Type Test Report

Impact sound insulation box Egcosono SP

T 22/006/351 | 18.05.2022

TYPE TEST REPORT
No. T 22/006/351

name: Egcosono SPL	
scale: 1 : 5	unit: mm
drawn: BW	date: 28.03.2022
MAX FRANK BUILDING COMMONGROUND

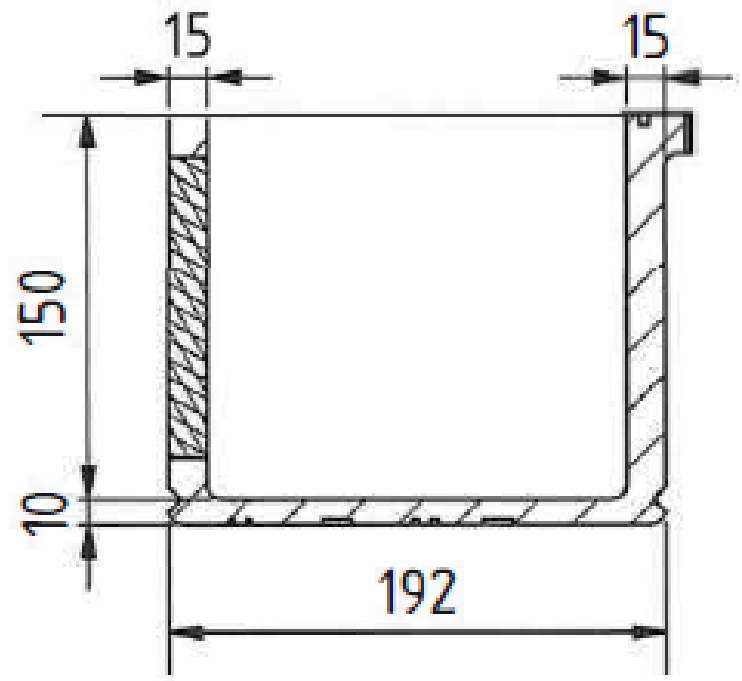
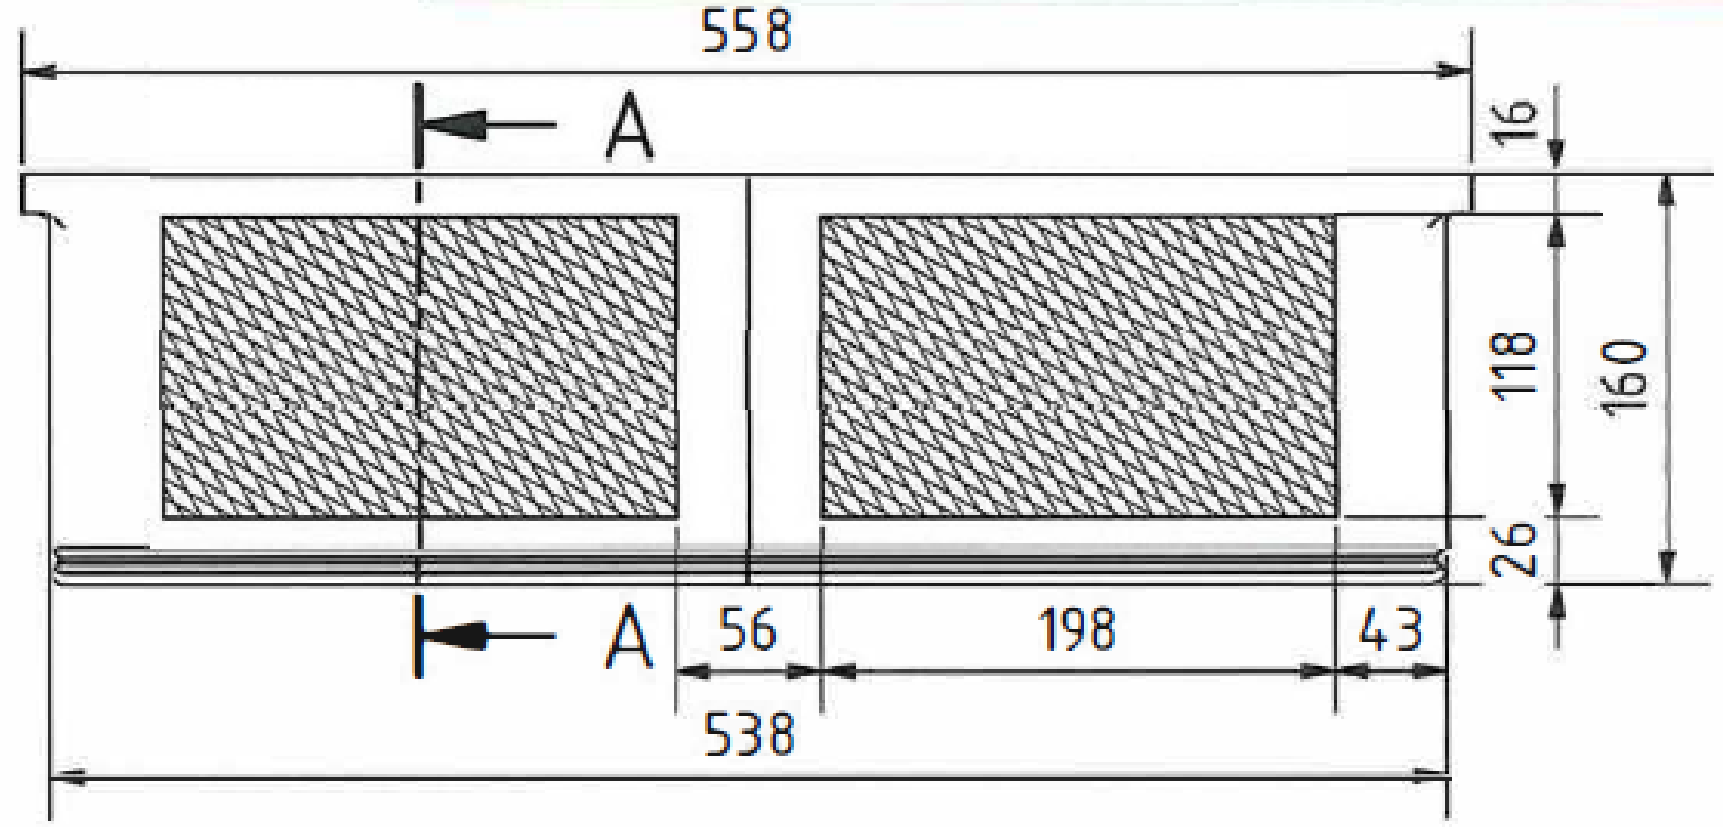
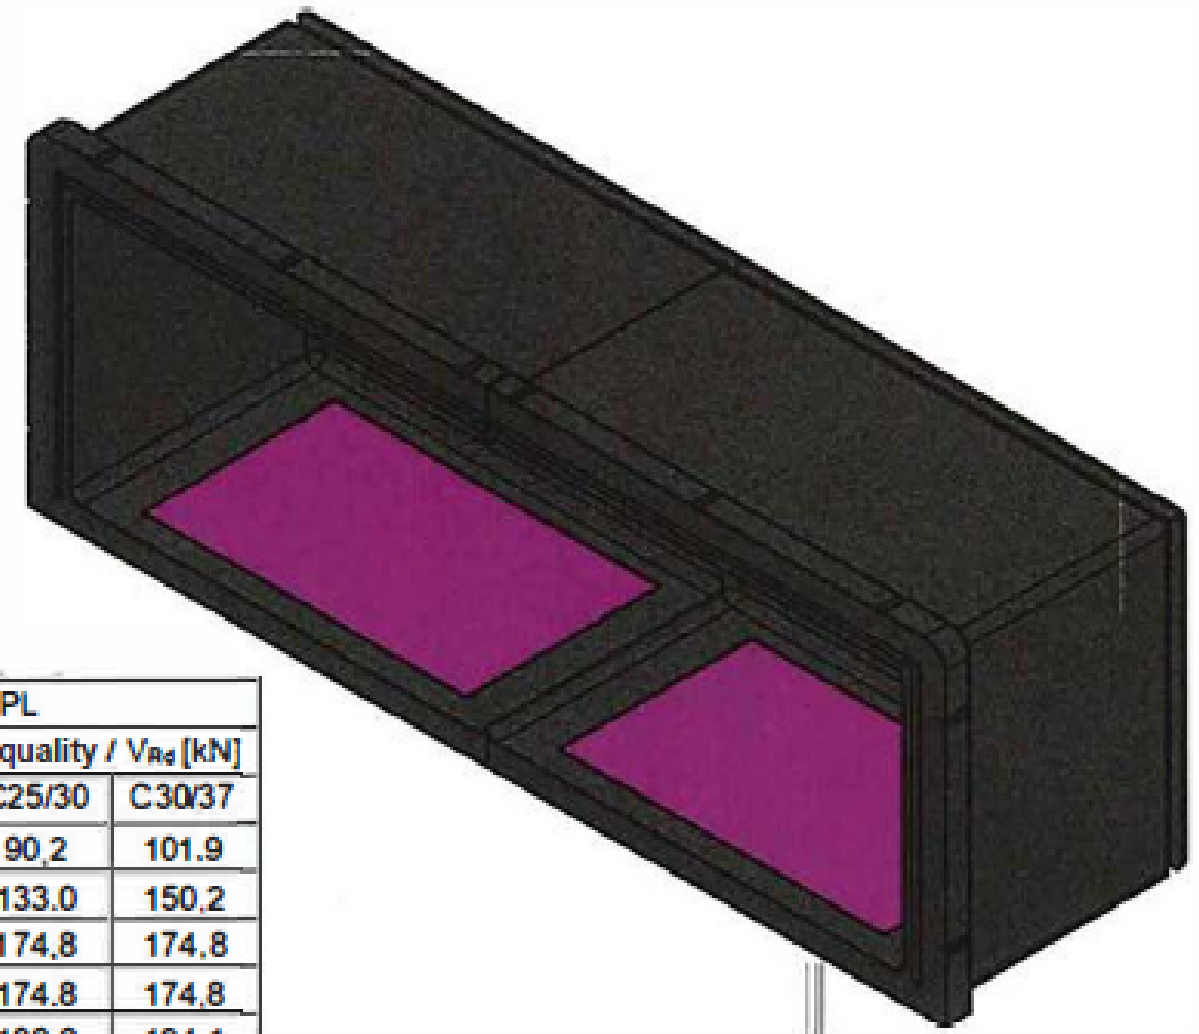
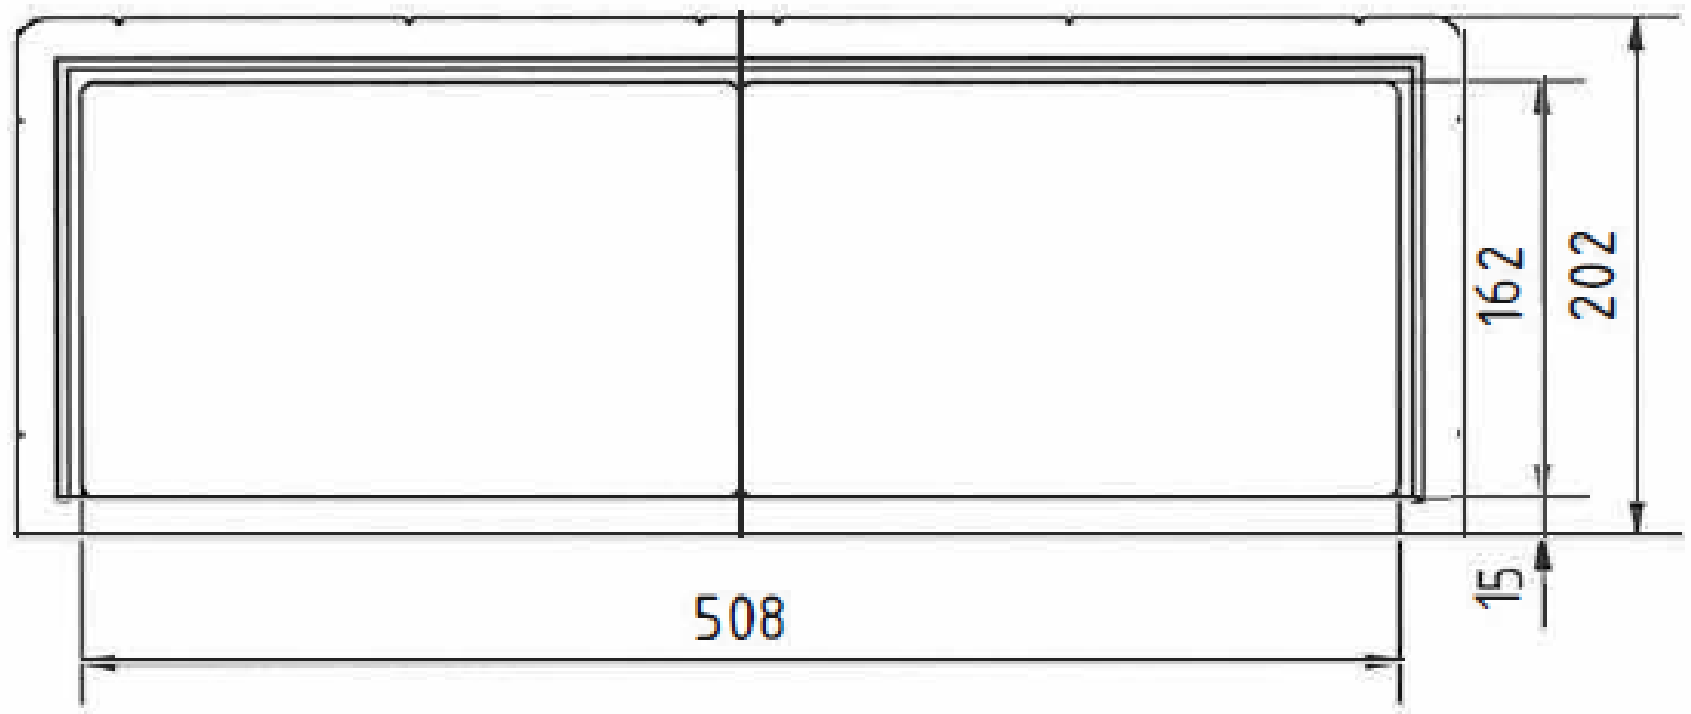
Durch Vergleichsrechnung geprüft
